PRODUCT NOTICE # 5-21-10-2

VGEN2 (+3.15V) Regulation

ConnectCore Wi-i.MX51

Figure 1: General orientation of module

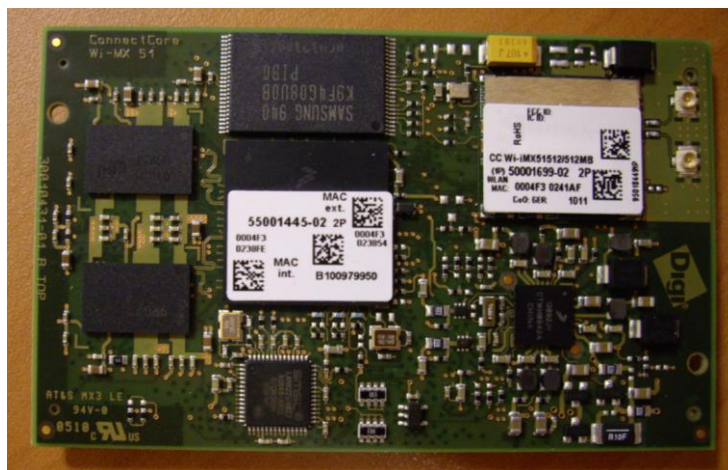
In order to aid in the visual inspection process, the close-up images provided below outline the location of the PCB related Digi part number and revision information.

Figure 2: Close-up of PCB part number and revision information

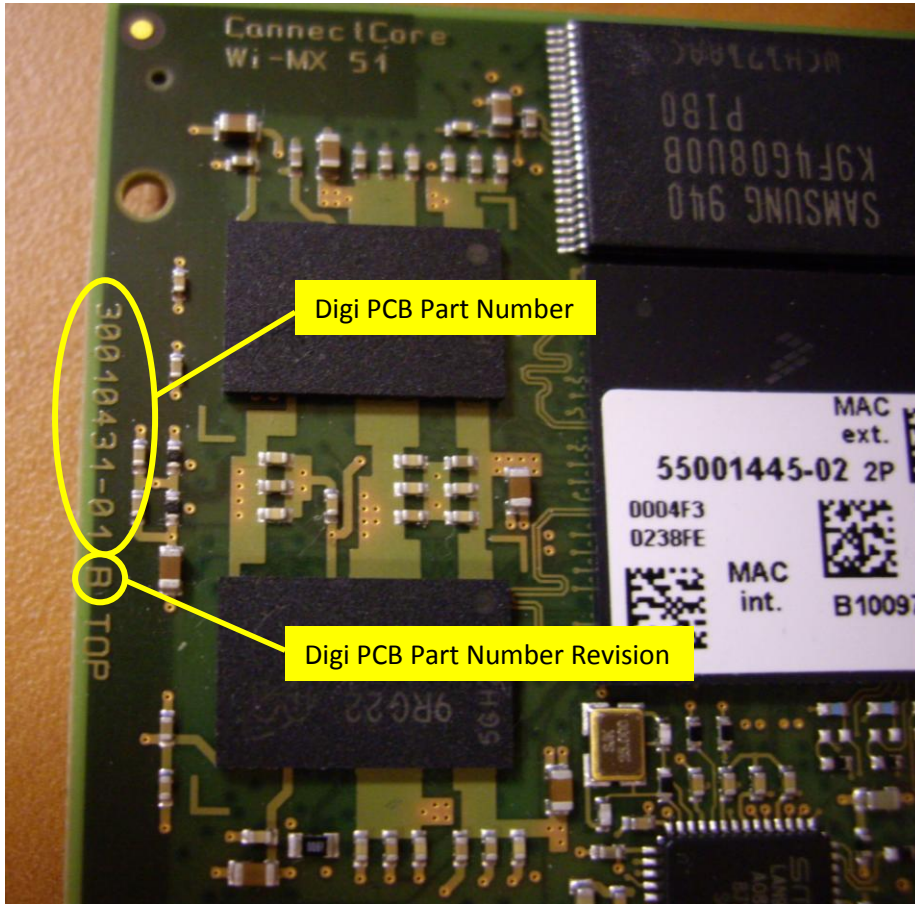
The issue applies to the module PCB with Digi P/N **3001043x-01** revision **A** and **B** only.
